APPLICATION NO.	FILING DATE	FIRST NAMED INVENTOR	ATTORNEY DOCKET NO.	CONFIRMATION NO.
10/611,956	07/03/2003	Andy Chen	089048-0289	3550
22428	7590	09/01/2004	EXAMINER	
FOLEY AND LARDNER SUITE 500 3000 K STREET NW WASHINGTON, DC 20007			SZUMNY, JONATHON A	
			ART UNIT	PAPER NUMBER
			3632

## Office Action Summary

This is the first office action for application number 10/611,956, Rotary Supporting Base for a Display Device, filed on July 3, 2003.

Patent number 5,518,216 to Wu.

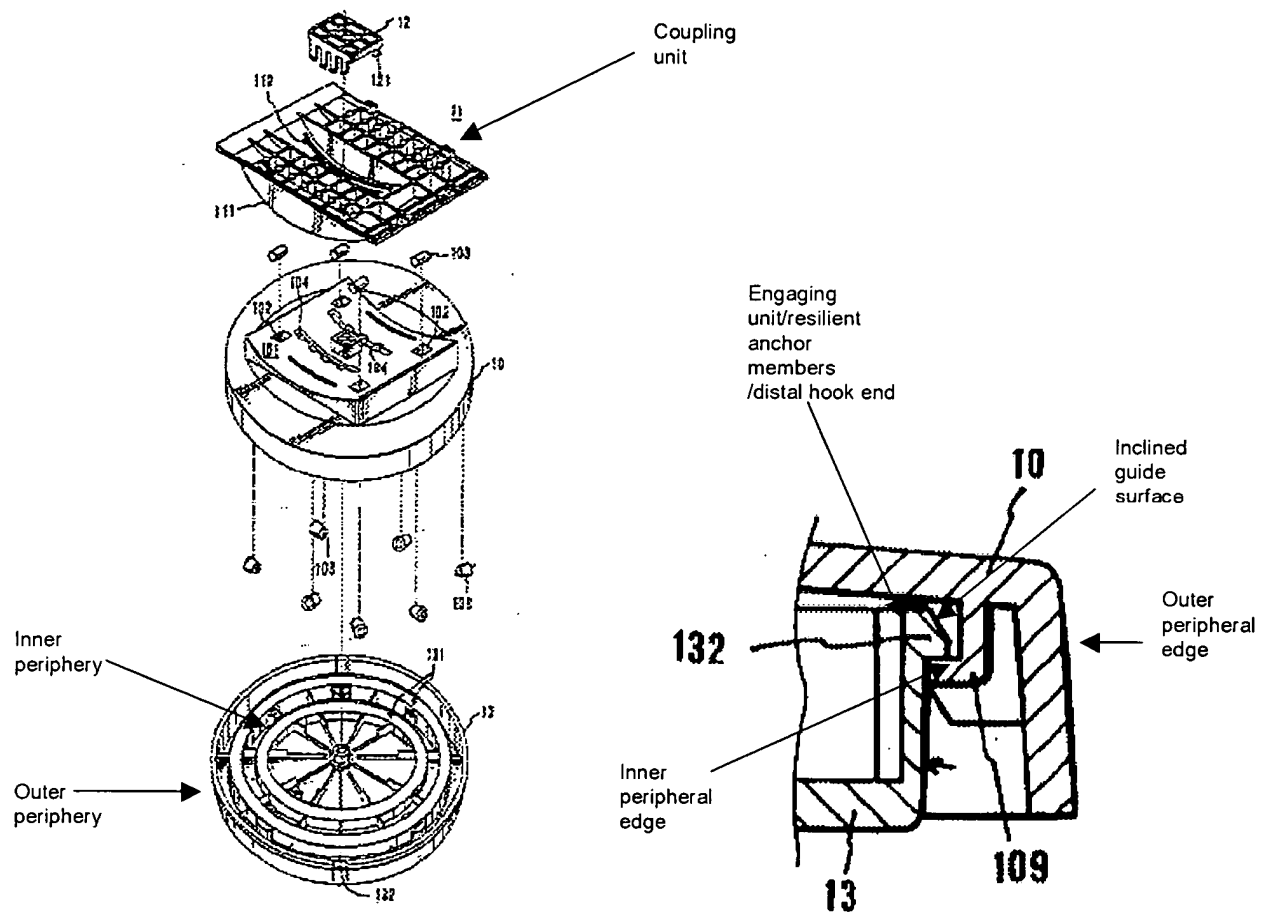
Claims 1-3 are rejected under 35 U.S.C. 102(b) as being anticipated by U.S.

Wu '216 discloses a rotary supporting base (figure 1) comprising a stationary lower base member (13) having a top surface formed with a ring-supporting region that is confined by an inner periphery and an outer periphery (above) that is concentric with and that surrounds said inner periphery, said lower base member being further formed with an engaging unit (above) on at least one of said inner and outer peripheries; a

coupling ring plate (10) disposed on said top surface of said lower base member at said ring-supporting region and rotatable relative to said lower base member about a rotary axis transverse to said top surface of said lower base member, said coupling ring plate having inner and outer peripheral edges (above), at least one of which is in sliding engagement with said engaging unit to retain rotatably said coupling ring plate on said top surface of said lower base member; a rotatable upper base member (11) disposed on top of said lower base member and coupled to said coupling ring plate for co-rotation therewith relative to said lower base member; and a coupling unit (above) provided on at least one of said coupling ring plate and said upper base member; wherein said engaging unit includes a plurality of resilient anchor members (above), each of which extends uprightly from said top surface of said lower base member and has a distal hook end (above) spaced apart from said top surface of said lower base member, said distal hook end abutting against said coupling ring plate to arrest upward movement of said coupling ring plate away from said lower base member; wherein said distal hook end of each of said anchor members has an inclined guide surface (above) that guides downward movement of said coupling ring plate toward said ring-supporting region on said top surface of said lower base member.

Claims 1 and 4-6 are rejected under 35 U.S.C. 102(b) as being anticipated by U.S. Patent number 3,936,026 to Hampel et al.

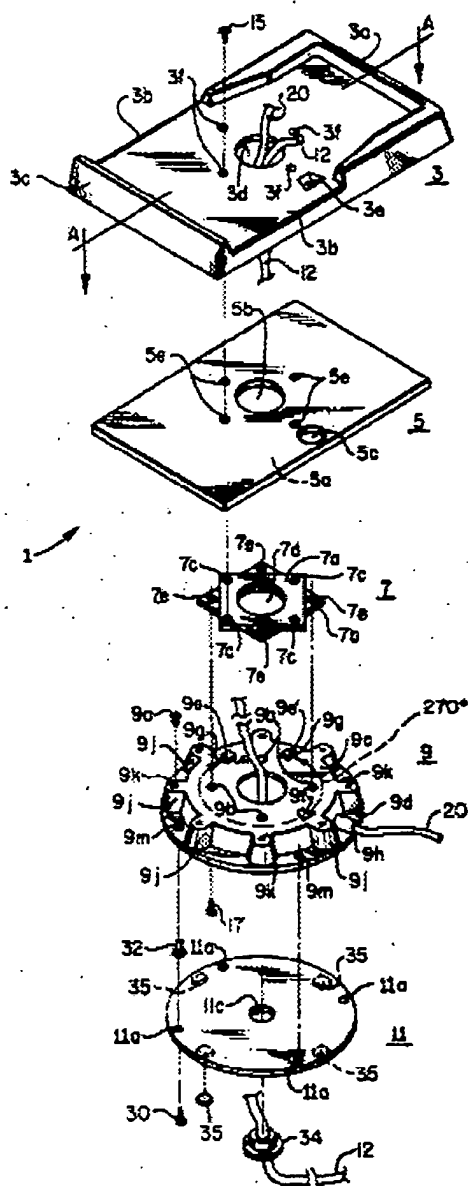
Hampel et al. '026 discloses a rotary supporting base (figure 1) comprising a stationary lower base member (7b) having a top surface formed with a ring-supporting region that is confined by an inner periphery and an outer periphery (outer edge and race of ball bearing race on line 54, column 3) that is concentric with and that surrounds

said inner periphery, said lower base member being further formed with an engaging unit (ball bearing race, column 3, line 54) on at least one of said inner and outer peripheries; a coupling ring plate (7a) disposed on said top surface of said lower base member at said ring-supporting region and rotatable relative to said lower base member about a rotary axis transverse to said top surface of said lower base member, said coupling ring plate having inner and outer peripheral edges (race of ball bearing race and the outer edge of plate), at least one of which is in sliding engagement with said engaging unit to retain rotatably said coupling ring plate on said top surface of said lower base member; a rotatable upper base member (5) disposed on top of said lower base member and coupled to said coupling ring plate for co-rotation therewith relative to said lower base member; and a coupling unit (3) provided on at least one of said coupling ring plate and said upper base member, further comprising a plurality of screw fasteners (15) for fastening said coupling ring plate to said upper base member; wherein said coupling ring plate is formed with a plurality of fastener holes, and said upper base member is formed with a plurality of screw sockets registered with said fastener holes, said screw fasteners extending through said fastener holes and engaging said screw sockets, respectively; wherein said coupling unit includes an outer tube segment (clearly, member 3 could inherently be a "segment" of an "outer tube" if for instance an outer tube was fitted through opening 3d) extending uprightly from said upper base member.
